Daimler Buses North America Recall Bulletin

Orion V, VII Models

NHTSA 10V-015 / Transport Canada Number 2010006

REMOTE THROTTLE CONTROL RECALL NOTICE

FIGURE 1-3 TYPE B - REWORKED

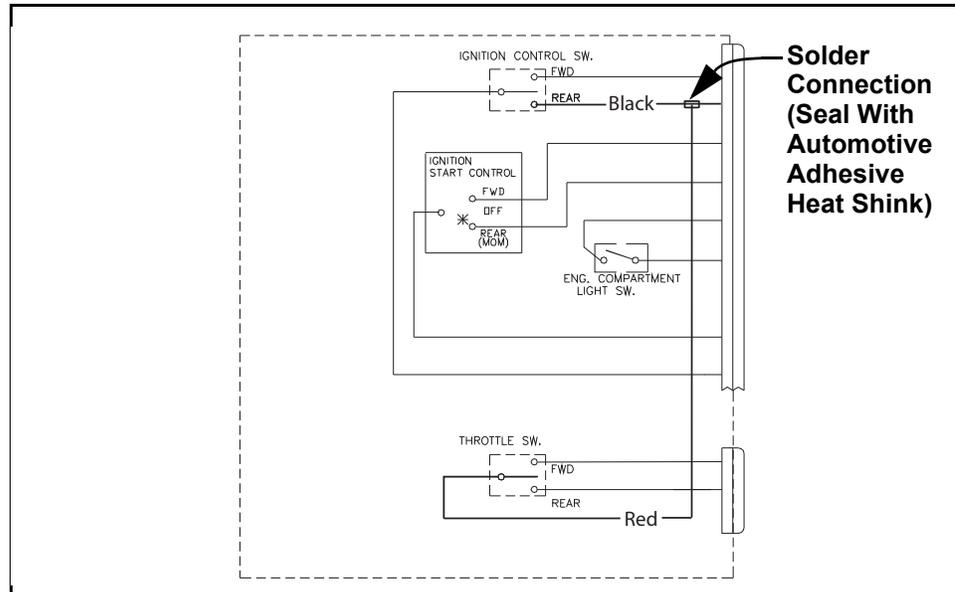
1. Access the backside of the rear engine panel as necessary.
2. Locate the THROTTLE SWITCH connector on the rear engine control panel.
3. Remove the RED wire from the THROTTLE SWITCH connector (pin "B").
4. Remove pin terminal from RED wire.
5. Cut the BLACK wire to the IGNITION switch.
6. Strip the end of BLACK wire attached to IGNITION switch.

7. Twist the RED wire from THROTTLE SWITCH together with stripped end of BLACK wire attached to IGNITION switch.
8. Strip remaining end of BLACK wire attached to vehicle harness.
9. Slide 1" section of automotive grade adhesive heat shrink tubing onto BLACK wire attached to vehicle harness.
10. Twist the BLACK wire from step 5 together with the RED/BLACK connection from step 3.
11. Solder twisted RED/BLACK wires from IGNITION switch to stripped end of BLACK wire from vehicle harness.
12. Slide heat shrink over soldered connection and apply heat to seal the connection.
13. Insert W/P cavity plug into empty cavity B of THROTTLE SWITCH connector. Reworked configuration should appear as shown in [Figure 1-3](#).

FIGURE 1-4 TYPE A - REWORKED

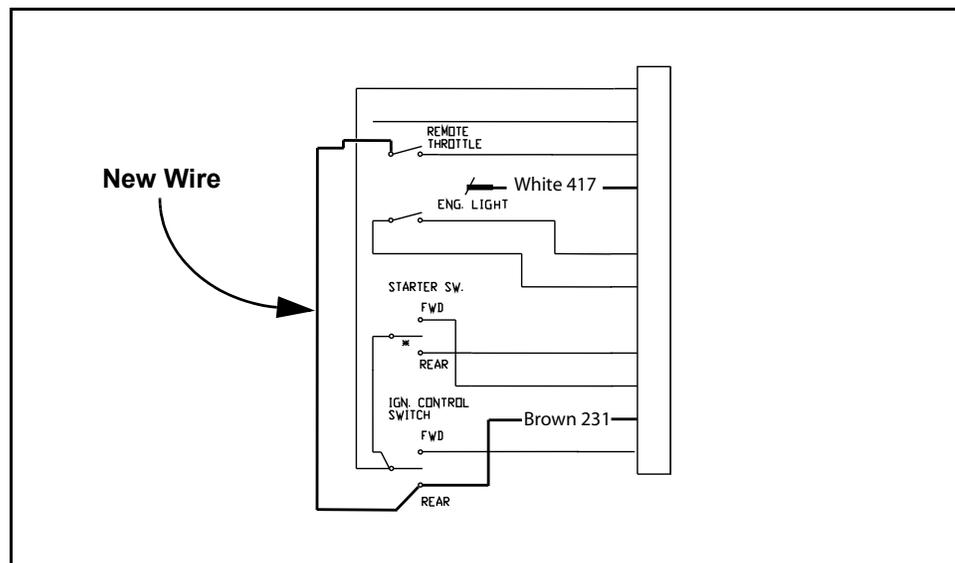
1. Access the backside of the rear engine panel as necessary.
2. Remove the white wire labeled 417 ring terminal from the REMOTE THROTTLE switch. Insulate this wire end by cutting the terminal off and sealing the end of the wire with automotive grade adhesive heat shrink insulation.

3. Make a wire assembly of 16 AWG wire having a ring terminal on each end sized the same as that removed from White wire 417. The length of wire shall run from the REMOTE THROTTLE switch on the remote panel box to the IGNITION switch where the Brown 231 terminal connects.

4. Connect this wire assembly to the terminal where the wire labeled 417 ring terminal was on the REMOTE THROTTLE switch.
5. Connect the other end of this wire assembly to the remote panel box IGNITION switch where the Brown 231 terminal connects. Stack the existing Brown 231 terminal and the new wire assembly.

6. Verify that the Brown 231 terminal has continuity to ground. Reworked configuration should appear as shown in [Figure 1-4](#).
